Number: TSB-FC-2015-025 CS7000

Symptom: Squeegee will not lower– Error Code 39 on display

Date: 20th July, 2015

Fig.1

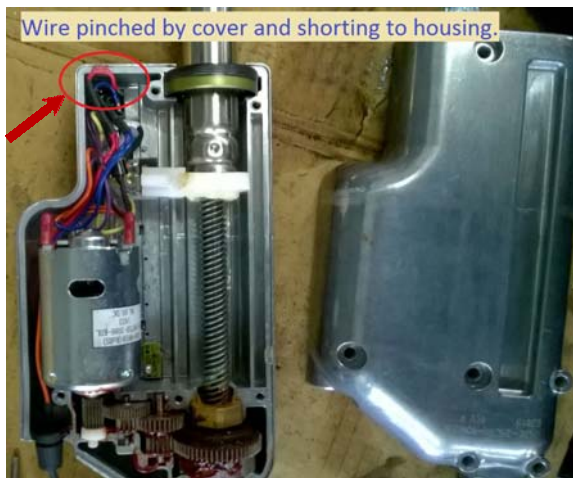
Replace Main Control Board. Before installing new board, the wiring to the actuator should be checked for a short to the frame. The internal wires in the squeegee actuator should be inspected for a possible internal short to the housing. Remove the actuator cover and inspect the wires. See Fig.1 & 2

56511565 CONTROL BOARD KIT - To resolve main control board issue with squeegee actuator circuit

56509247 ACTUATOR SQUEEGEE LIFT - If internal short is found or if actuator is drawing more than 5A while running
